## ADDENDUM

### MEETING OF THE PLANNING COMMITTEE

WEDNESDAY 8<sup>th</sup> JUNE 2022

#### PLANNING APPLICATION: 21/03303/F - Titan House Crossoak Lane Salfords Surrey RH1 5EX

Drawing No.: 2105-PL-0001 Rev: P3

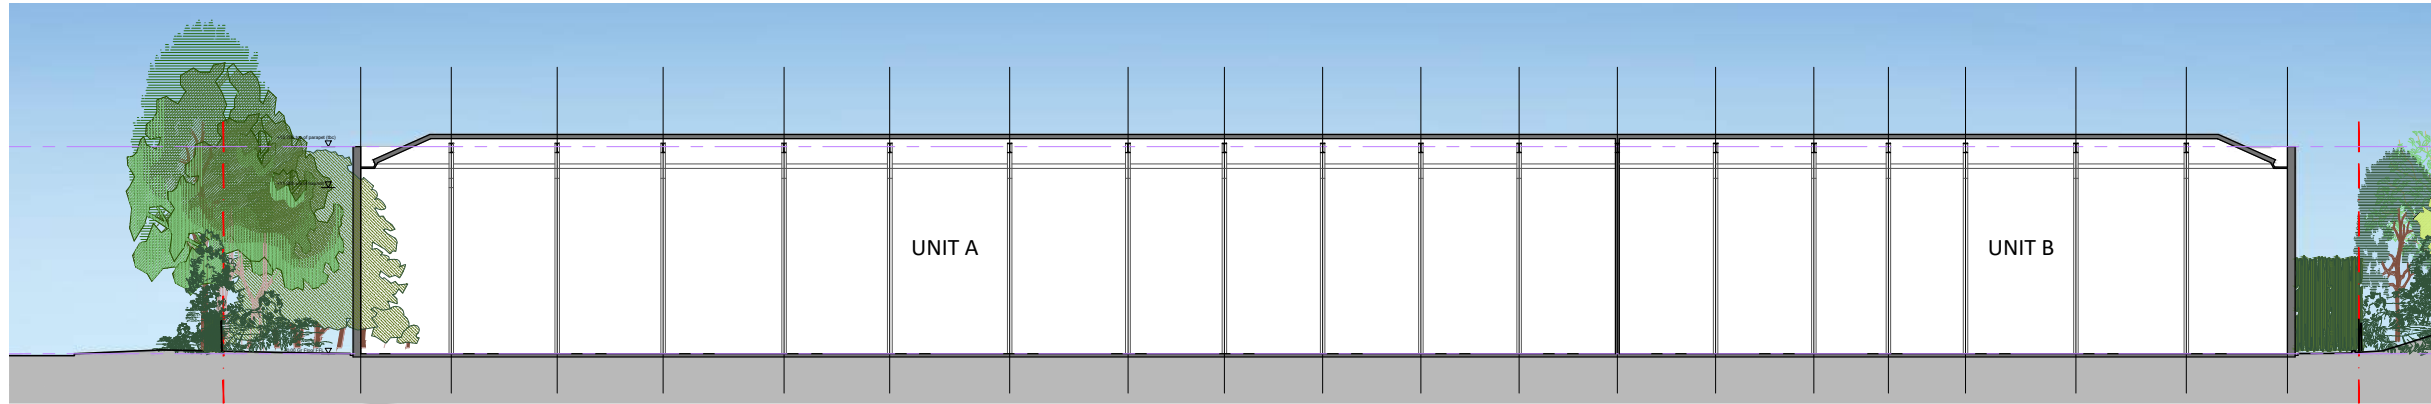
- Appendix A – site layout plan showing distances to the nearest properties and 45 degree line with no.11 Empire Villas
- Appendix B – cross section between unit B and 11 Empire Villas, including 45 degree line. Cross Section between unit A and 5 Empire Villas, including 25 degree line
- Appendix C - Cross Section between unit A and 5 Empire Villas, including 25 degree line. North Site Boundary elevation looking from Empire Villas.

22. The development hereby approved shall not be first occupied unless and until space has been laid out within the site in accordance with approved plan numbered 2105 PL 001 Rev3 and/or 2105 PL 0003 Rev 3 . for vehicles to be parked and for vehicles to turn so that they may enter and leave the site in

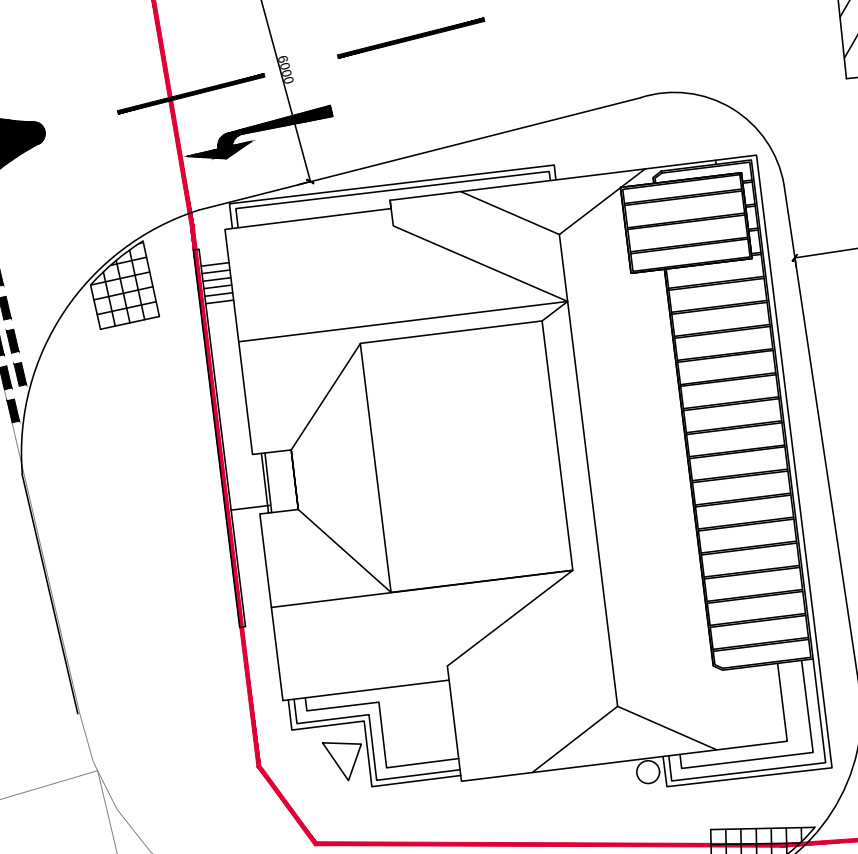
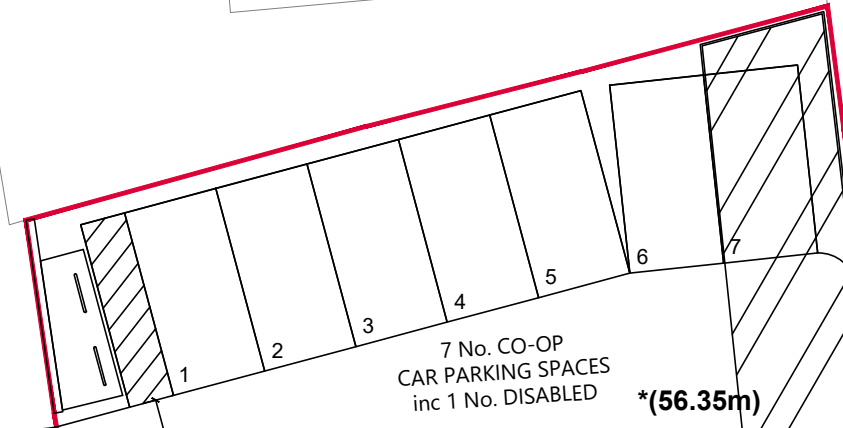
Additional 3D illustrative plans are provided at Appendix D and a revised side elevation at Appendix E
